**Re: Draft Environmental Impact Report for the Market and Octavia
Neighborhood Plan**

Re: 2003.0347E- Market and Octavia Neighborhood Plan

Figure 4-14
Revised
Viewpoint S1: Market Street, Looking East

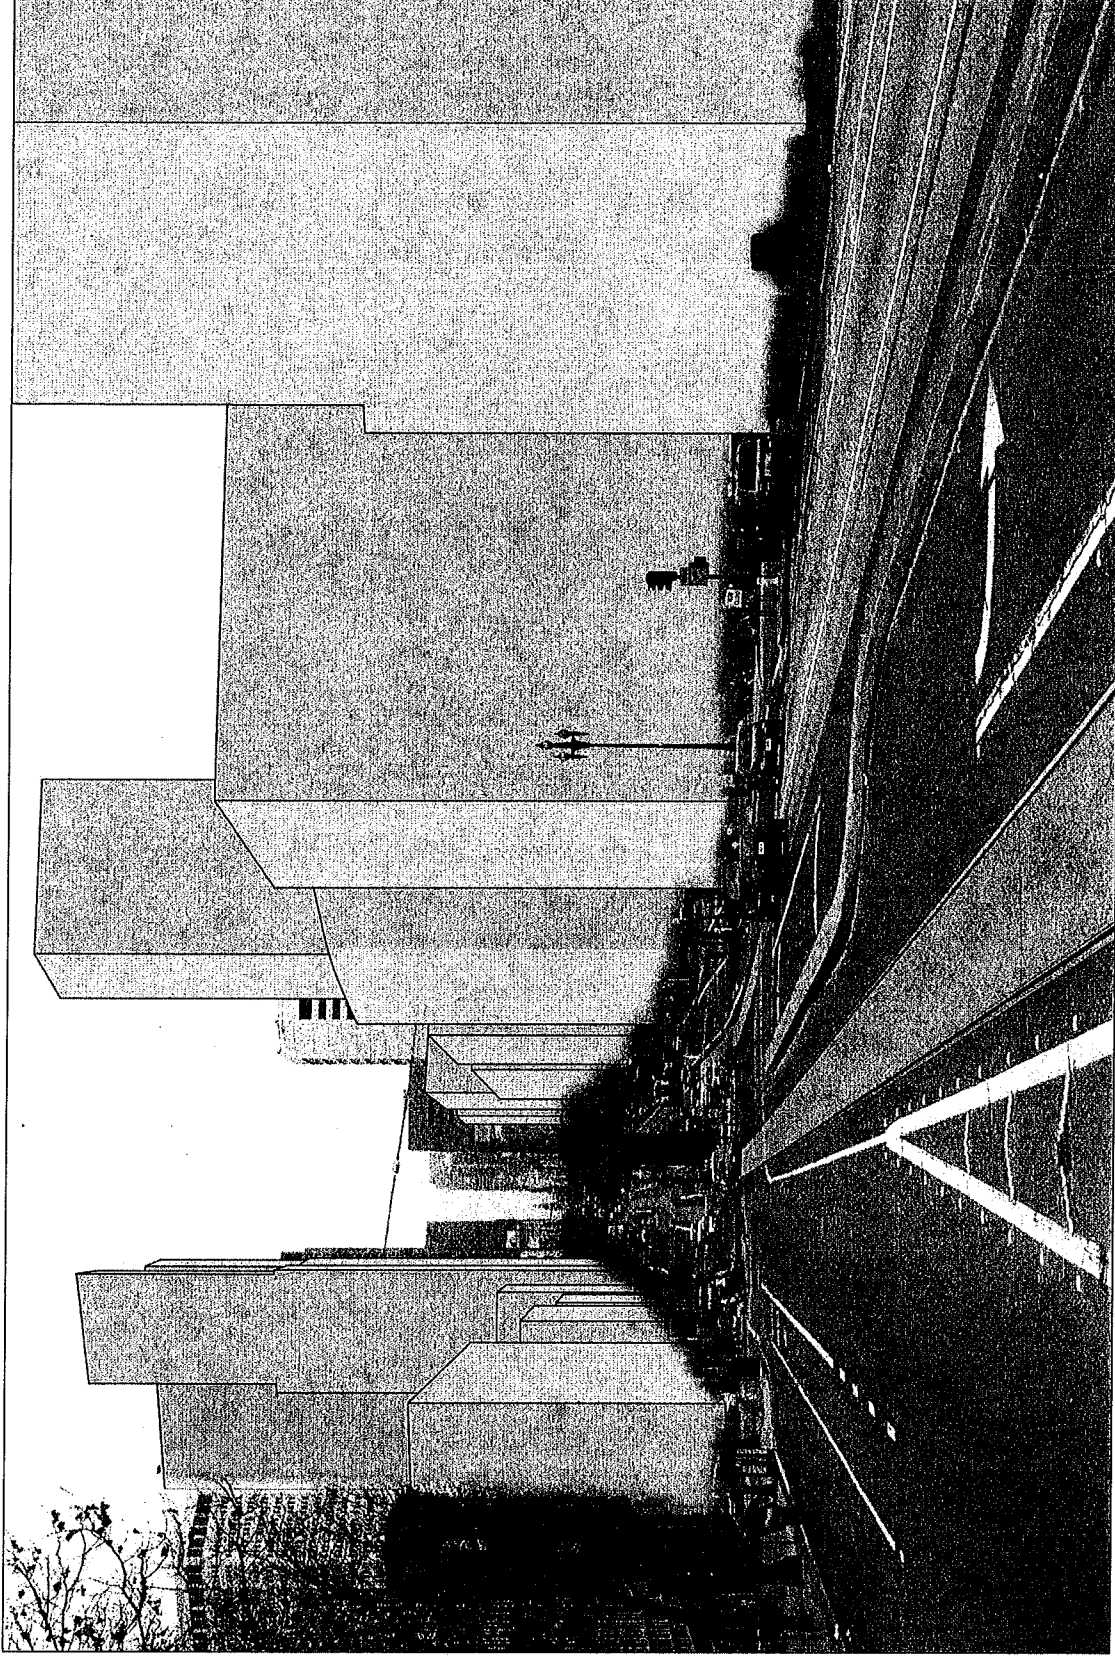
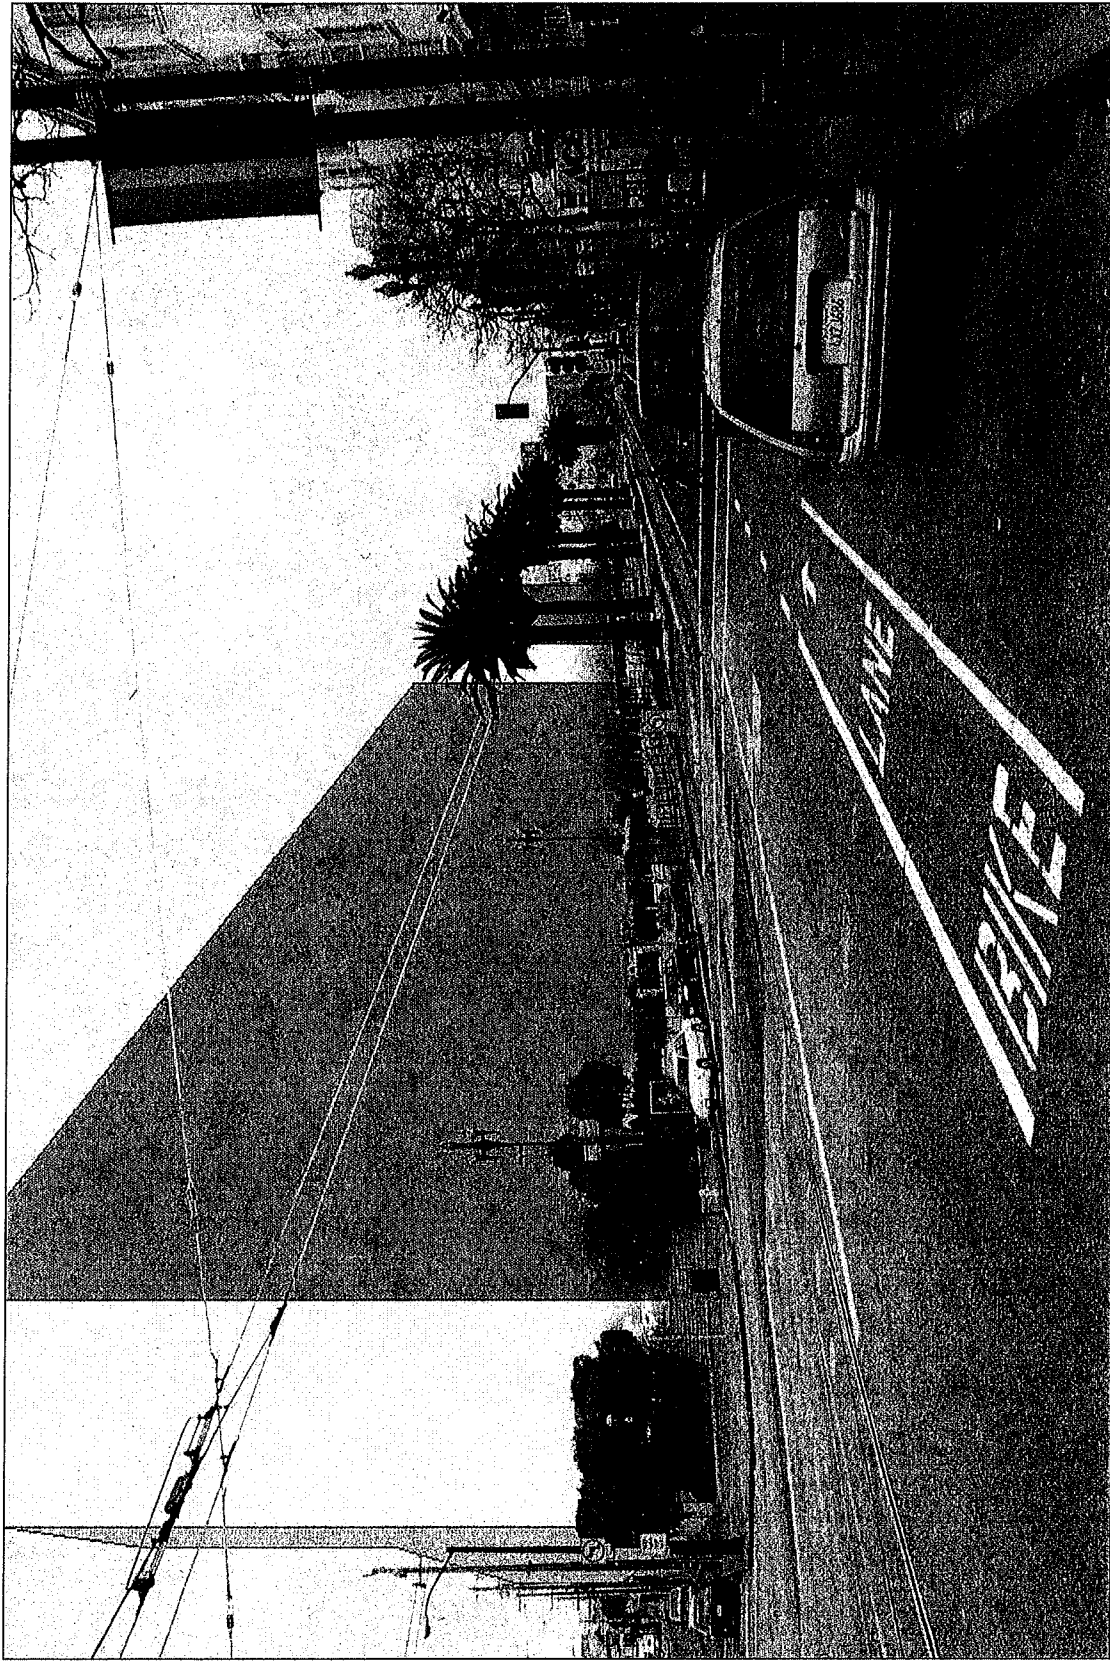
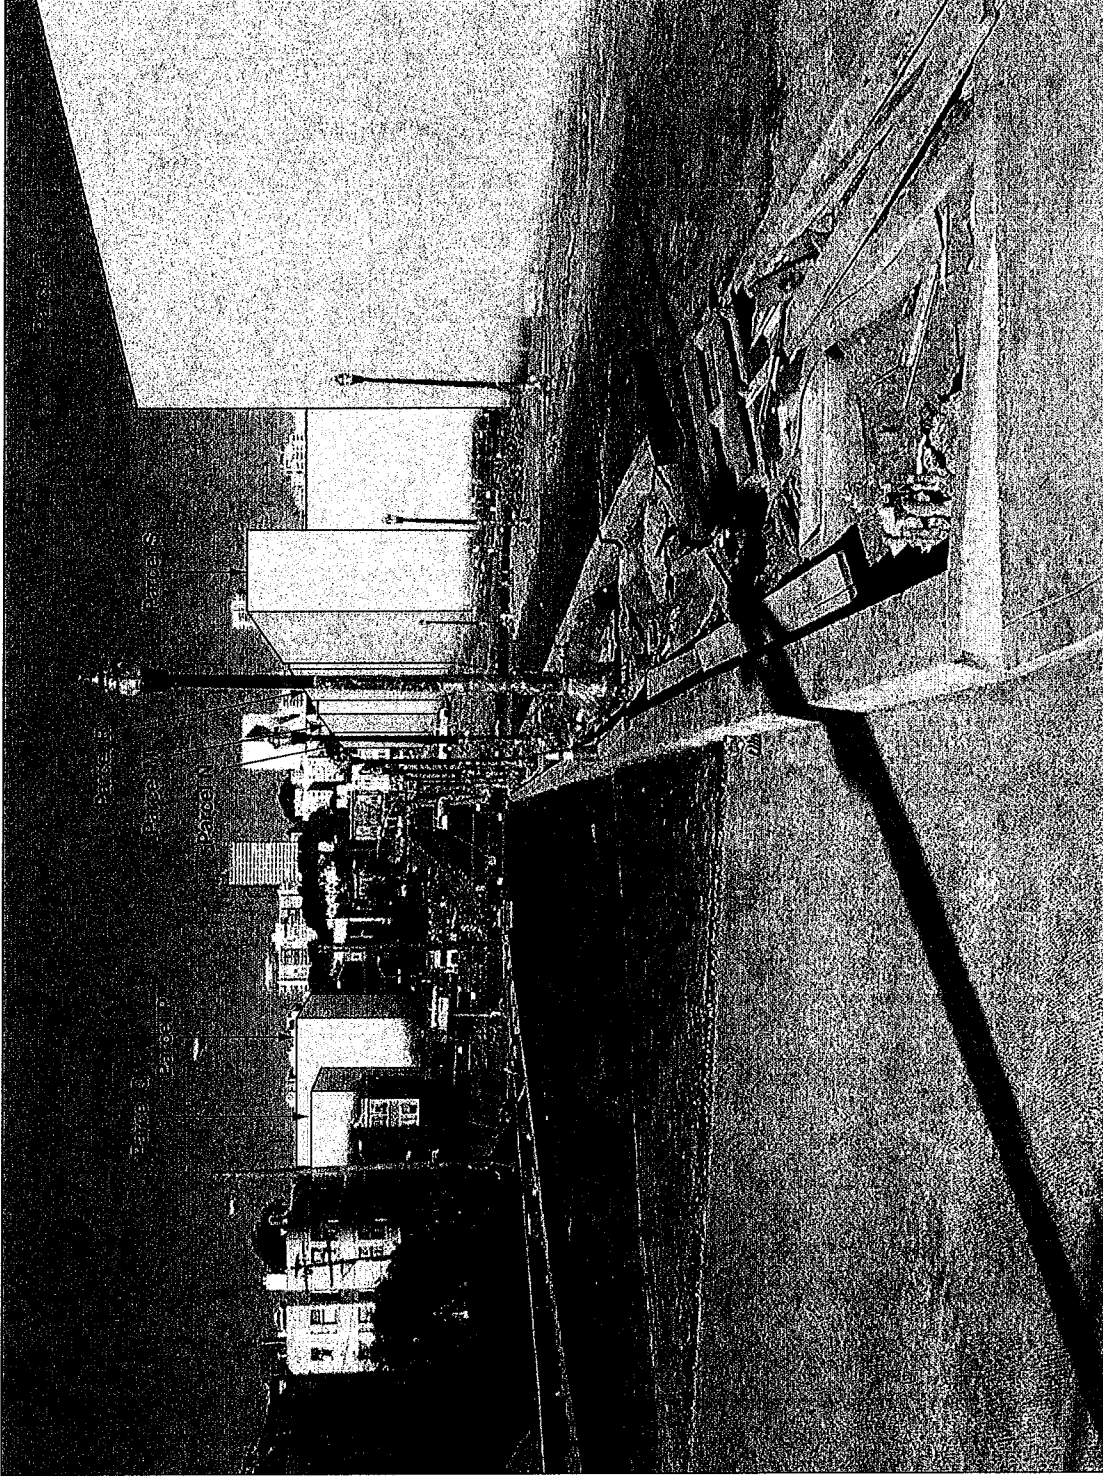
On Page 4-75, computer generated visual massing studies were generated. However, only two of those studies were included in the DEIR, Figure 4-14. These studies provides a false sense of the actual impact to the neighborhood by providing “wire-frame” outlines of the proposed height and bulk districts. By making these “buildings” transparent, the true impact of the proposed height and bulk

On Page 4-102, discussion is made of the redevelopment of the Safeway site, accompanied by Figure 4-15 which attempts to show the impact of new zoning on that site. Once again, the “wire-framing” of the outline of the proposed building gives a false sense of the visual impact at that location. In lieu of “wire-frame,” the transparent box should be filled with a gray color similar in tone to the existing building. This will present a more accurate reflection of the severe visual impact to the surrounding neighborhood. The computer generated visual massing studies are flawed.

could be lost due to the construction of buildings in conformance with the Plan. However, revised versions of Figures 4-14, 4-15 and 4-16, as presented on the following pages, that incorporate the background-fill suggested by the commenter are presented for consideration. While these revised figures provide a different perspective on the view impacts, they are likely to overstate the visual impacts of the Plan implementation as the exact configuration and design of future buildings are not known at this time.

Figure 4-14 on page 4-101 of the DEIR, Figure 4-15 on page 4-103 of the DEIR, and Figure 4-16 on page 4-109 of the DEIR are revised as shown on the following pages to include background fill.

**Figure 3-1
Revised
Location Map**

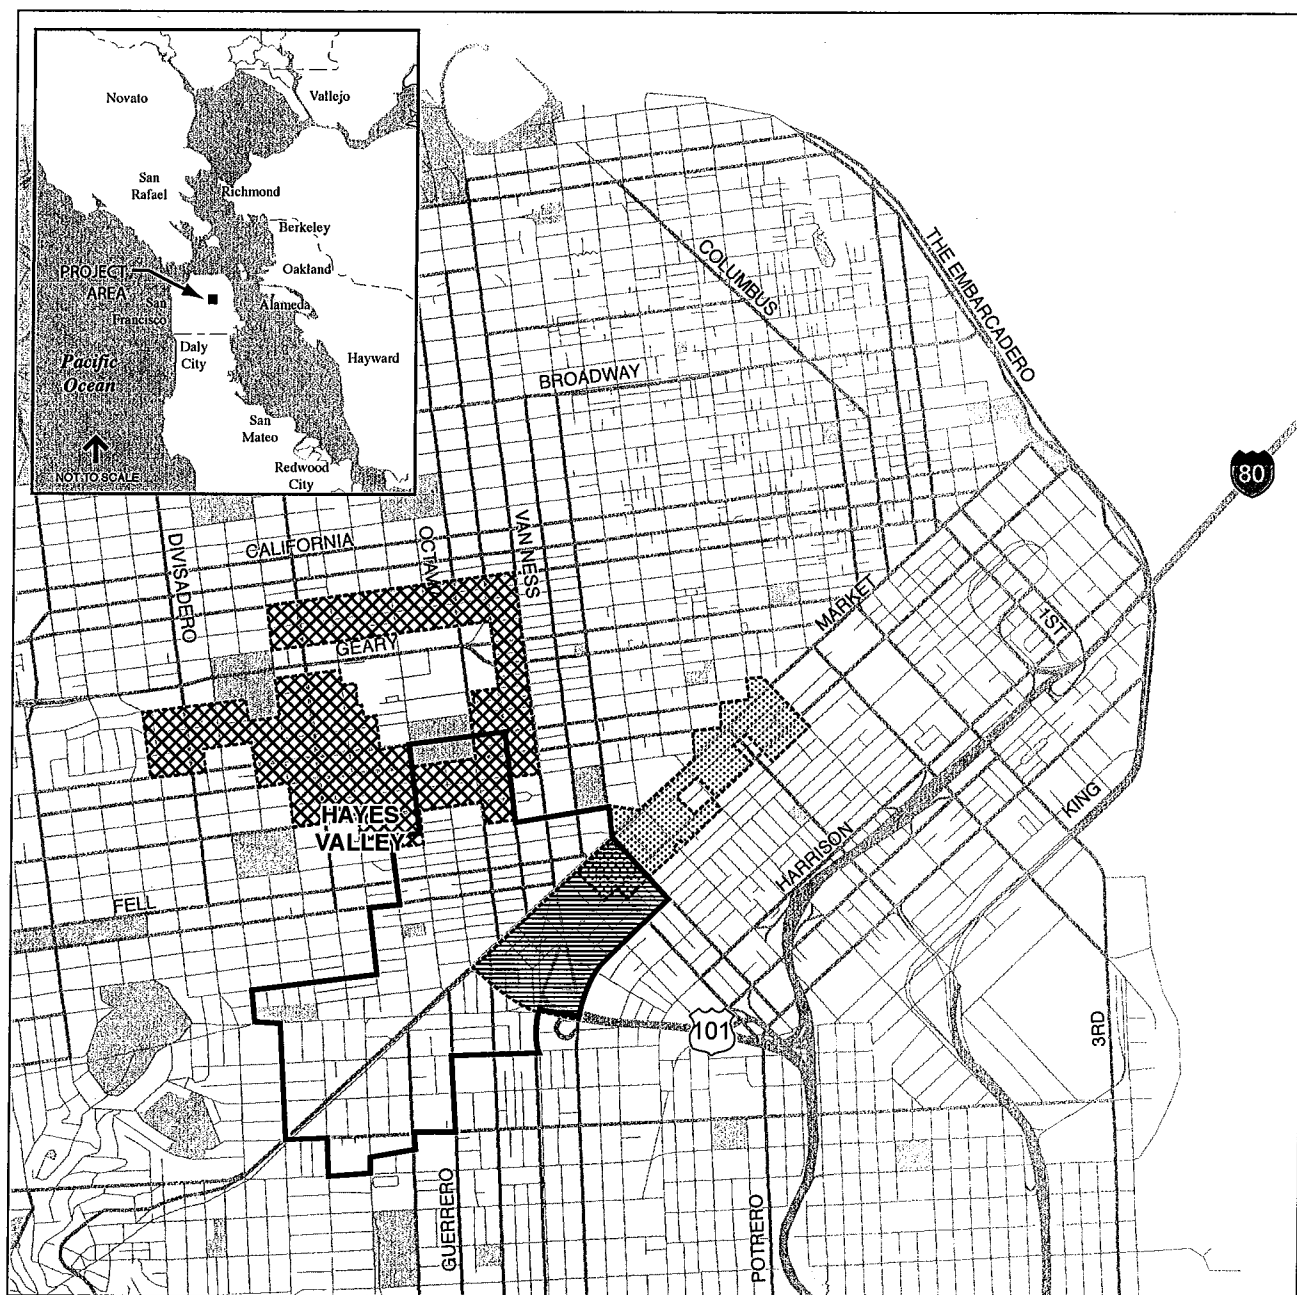
- Figure 3-1, page 3-5 of the DEIR is revised to correct the boundaries for the *Western Addition A-2 Redevelopment Plan* area. See Figure 3-1 on the following page.

Figure 4-2
Revised
Existing Use Districts

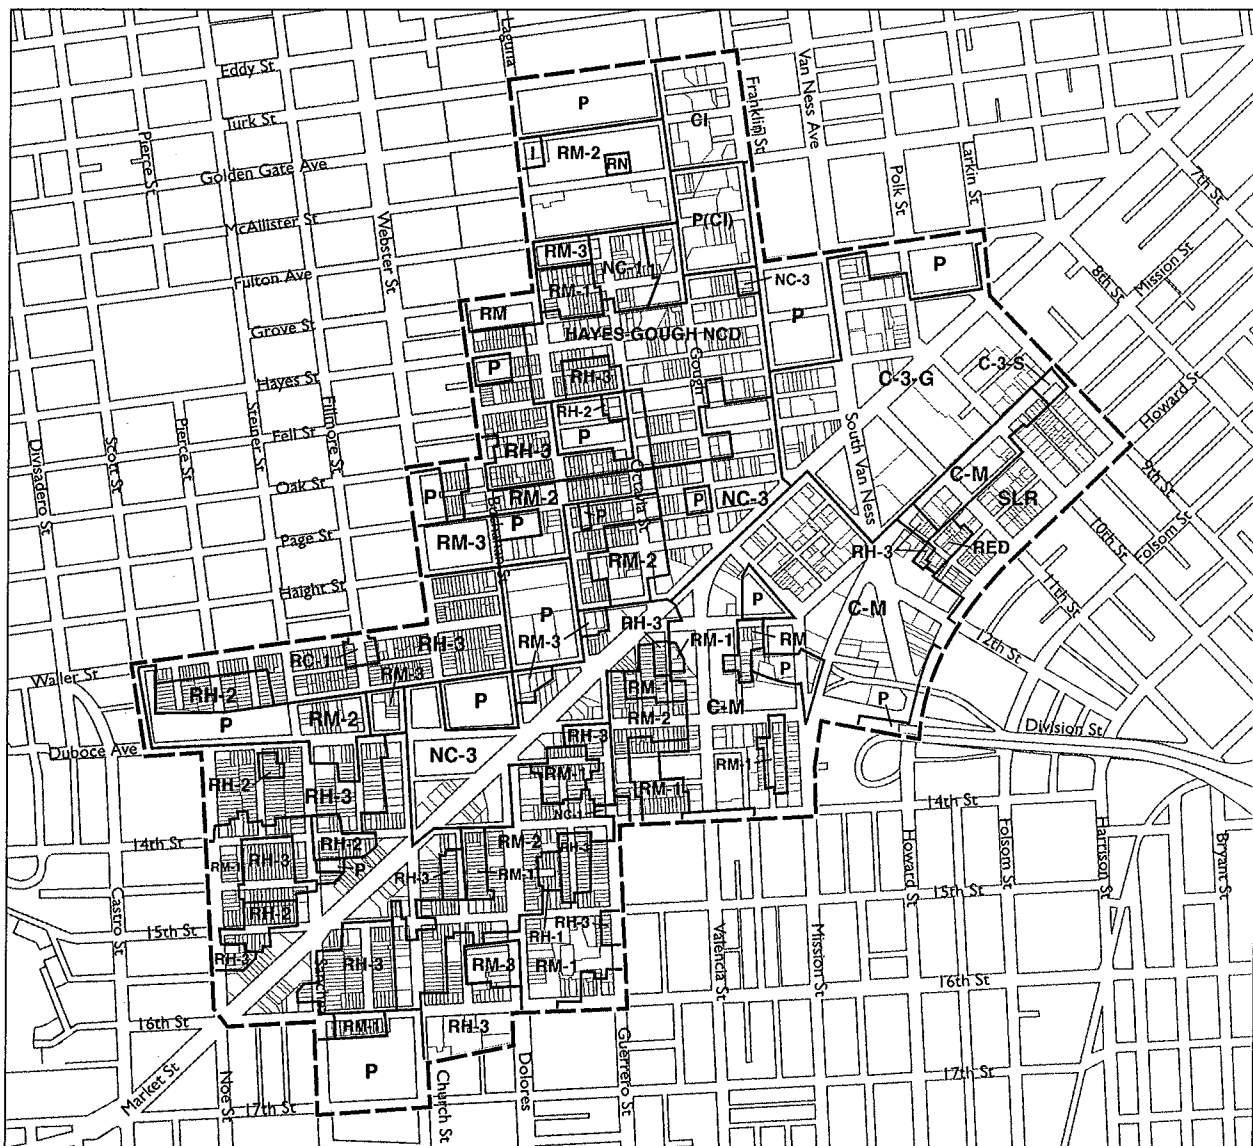
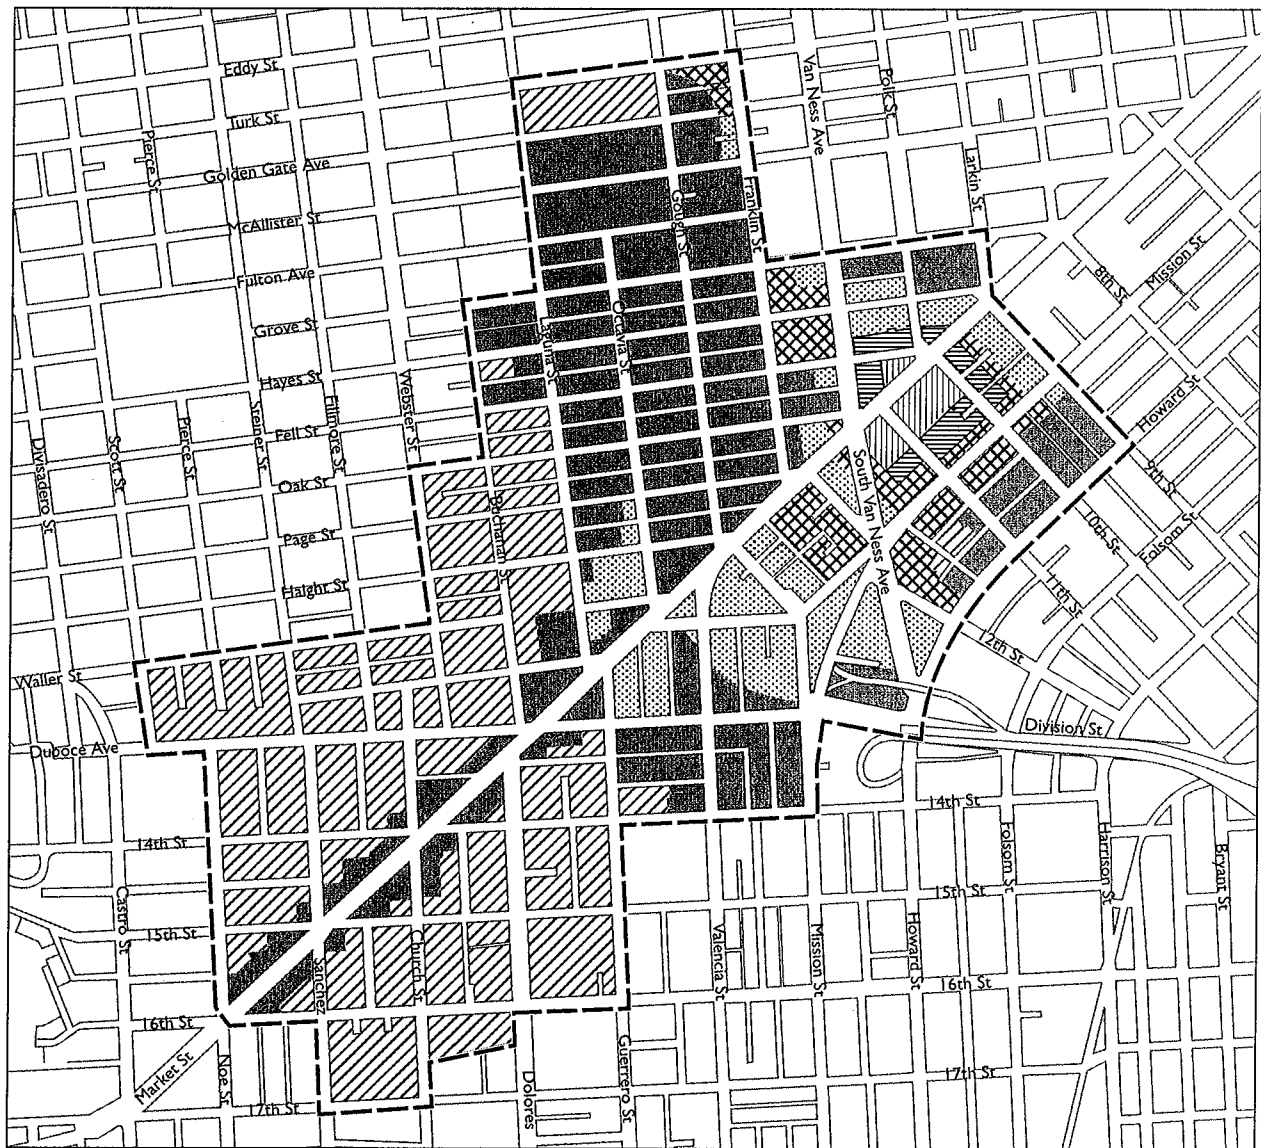
- Figure 4-2, page 4-38 of the DEIR is revised to show the *Western Addition A-2 Redevelopment Plan*
